UNITED STATES PATENT AND TRADEMARK OFFICE

10/667,144

Office Action Summary	Application No. 10/667,144	Applicant(s) CARLEY ET AL.	
	Examiner Lindsey Bachman	Art Unit 3734

DETAILED ACTION

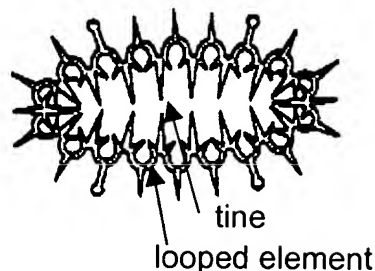
6. Spence'692 discloses a clip having a ring-shaped body (MR) defining a plane and disposed about a central axis (intersection of lines B-B and MLA in Figure 7), the body (MR) being movable from a planar configuration to a transverse configuration (column 8, lines 16-23). Further, the body (MR) contains a plurality of loop elements (see alternate embodiment in Figure 9b) and a plurality of tines (see labeled copy of Figure 9b below) extending from the looped elements towards the central axis. Further, Spence'692 teaches spring elements (82) that can be used to shape the clip (paragraph [0236]).

7. Regarding Claim 18, the spring element (82) taught by Spence'692 is biased to move the tips of the tines into the relaxed state.

8. Regarding Claim 19, Spence'692 discloses the looped elements (see Figure above) is a series of outer curved regions connected to one another and the tines (see Figure above) extend from the connection regions of the adjacent curved regions.

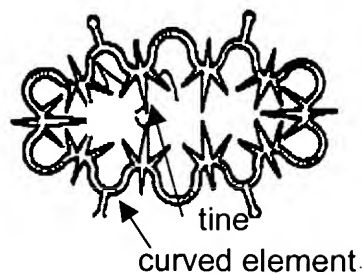
12. Regarding Claim 20, Spence'692 discloses a clip having a ring-shaped body (MR) defining a plane and disposed about a central axis (intersection of lines B-B and MLA in Figure 7), the body (MR) being movable from a planar configuration to a transverse configuration (column 8, lines 16-23). Further, the body (MR) contains a plurality of curved elements (see alternate embodiment in Figure 9c) and a plurality of arcuate tines (see labeled copy of Figure 9c below and arcuate features in element TB in Figure 8a) extending from the looped elements towards the central axis. Regarding Claim 20, Spence'692 does not teach arcuate tines.

13. Loshakove'704 teaches a clip that contains tines (210) which can be curved (column 5, lines 55-64) because this is a functional equivalent to the straight tines and the two types of tines can be used interchangeably. Further, curving spikes will keep them out of the same plane as the tabs (212) so that the clip can be maintained in the planar configuration (column 5, lines 41-50). Therefore it would have been obvious to one skilled in the art at the time the invention was made to use curved tines because they will aid in keeping the clip in a planar configuration.

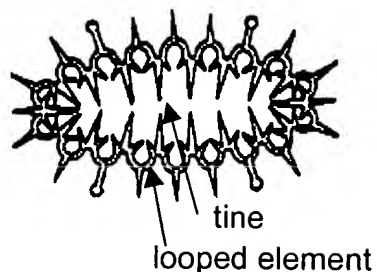
15. Spence'692 and Loshakove'704 teach the limitations of Claim 21 and 22, except for a spiral orientation of the arcuate tines.

16. Gifford'697 teaches a clip with a spiral orientation of tines (499) (see Figure 40a, 40b) because the spiral configuration allows the clip to be interlocked with another clip. The length of the tines is longer than the perimeter of the body because this length is necessary for interlocking. Therefore it would have been obvious to one skilled in the art at the time the invention was made to use a spiral configuration because it allows the clip to be interlocked with another clip.
